REPORT	Landscape Design Cover Letter
PROJECT NR.	19-013
PROJECT NAME	Rathborne 725 Residential Development Block 1, LRD Amendment Application
DATE	May 2024

Image 1. Grant of Planning Landscape layout.

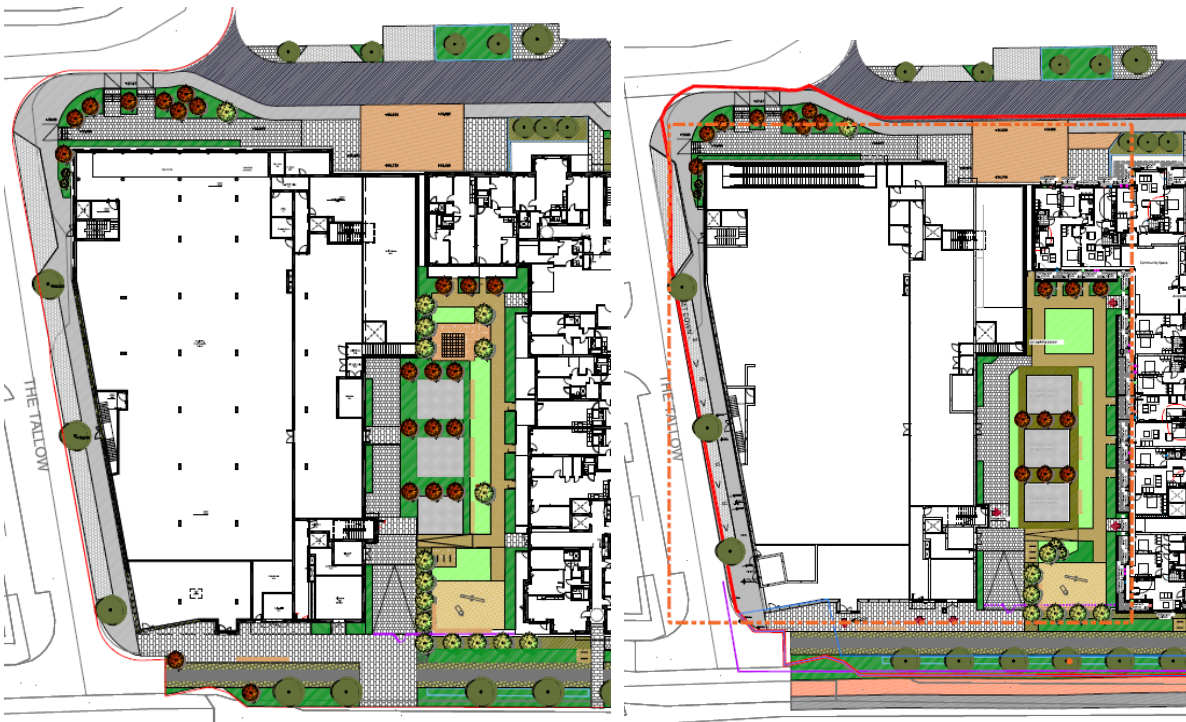
1. The relocation of 1no. Carparking space from the western boundary road at the south western site corner to north of Block 1. This is to accommodate access to the relocated ESB Substation,
2. The revisions to the courtyard between Block 1 and 2 to accommodate the relocated access points to Block 1.

The amenity and area of the courtyard between Block 1 and 2 under the Grant of Planning ABP-307656-20, as amended by ABP-312262-21, by DCC Reg Ref LRD6029/23-S3 and LRD6039/23-S3at Ashtown – Pelletstown, has not been reduced under this amendment application and remains as per the permitted arrangement.
